ST5010 (OCAMPA) and ST5011 (OCAMPA2) Comparison

And FCC Ruling

[Canada ID: 337J-WL0005](#) and [FCC ID: EJE-WL0005](#)

Ocampa and Ocampa2 are Host Pentablocks for Mini-PCI WLAN module (Calexico2)

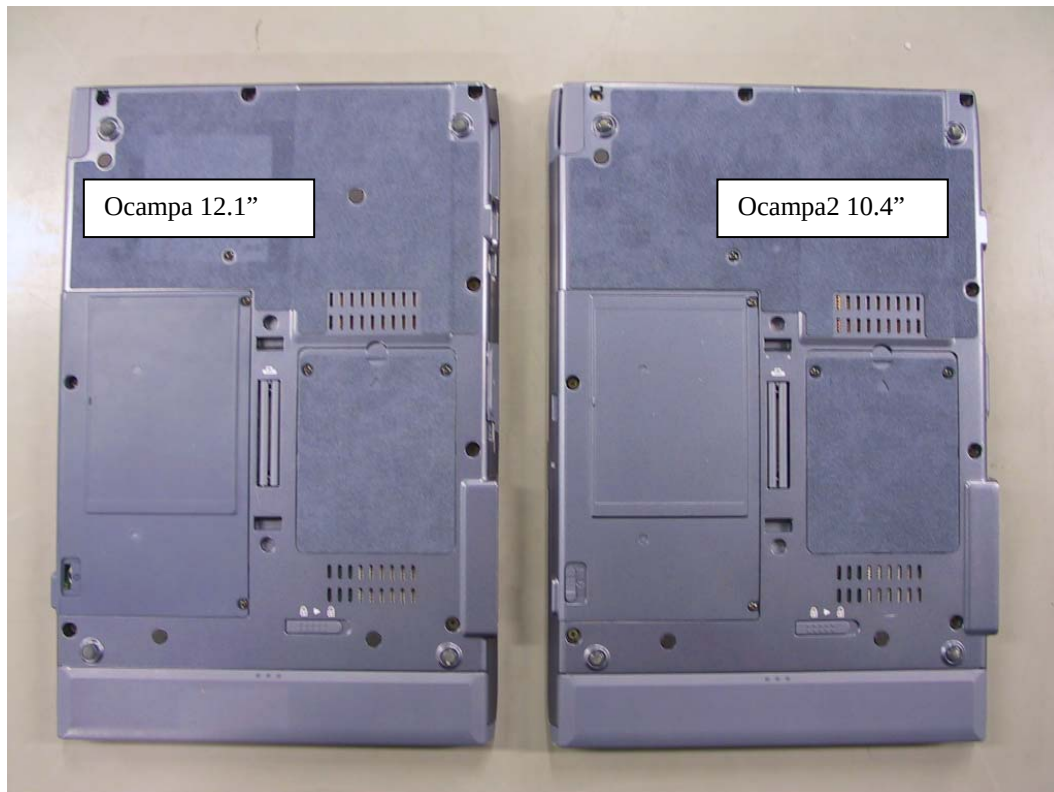
Parameter	OCAMPA	OCAMPA2
Model:	ST5010	ST5011
CPU	1 GHz	1 GHz
LCD Screen	12.1"	10.4"
All Other Parameters	SAME	
WLAN Module	SAME Calexico2 (Model: WM3B2200BG)	
Antenna	SAME Monopole YCE 5008	
Antenna Location	SAME	
All Radio Parameters	SAME
